DEVELOPMENT APPLICATION ASSESSMENT REPORT

Application Number:	DA2025/0384
----------------------------	-------------

Responsible Officer:	Brittany Harrison
Land to be developed (Address):	Lot B DP 409707, 58 A Elimatta Road MONA VALE NSW 2103 Lot 8 DP 611691, 56 Elimatta Road MONA VALE NSW 2103
Proposed Development:	Alterations and additions to a dwelling house including the subdivision of one lot into two and construction of a hardstand parking area and passing bay
Zoning:	C4 Environmental Living
Development Permissible:	Yes
Existing Use Rights:	No
Consent Authority:	Northern Beaches Council
Land and Environment Court Action:	No
Applicant:	Michael James Ludowici

Figure 1: Draft Plan of Subdivision, prepared by Adam Clerke, dated 27 November 2024.

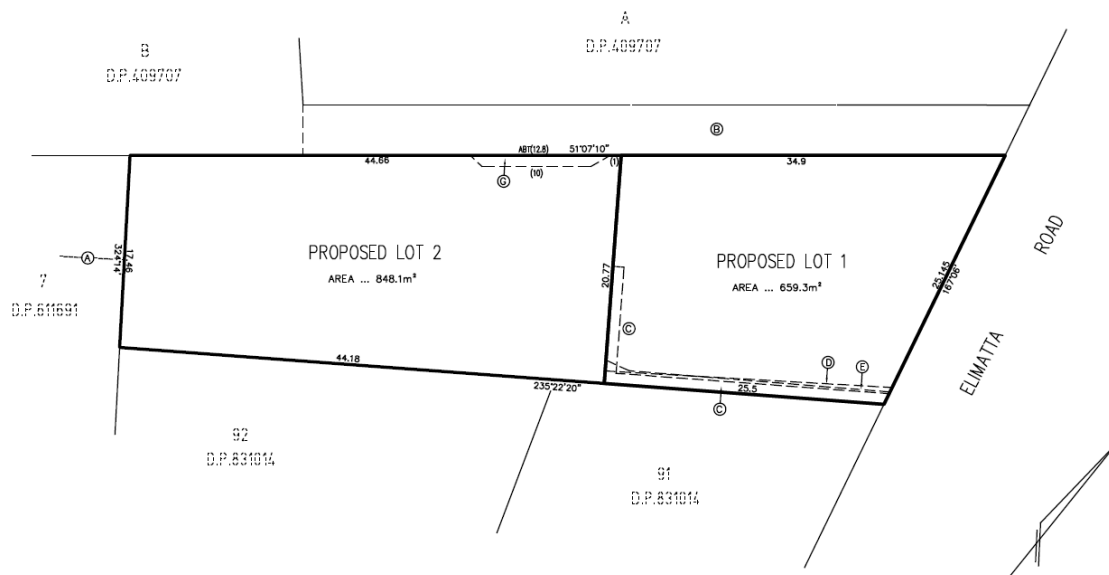
- Torrens Title Subdivision of the existing lot into two (2) new lots (see subdivision plan below);

Note: Proposed Lot 2 is to accommodate for the existing dwelling house and included alterations. Proposed Lot 1 is to be vacant.
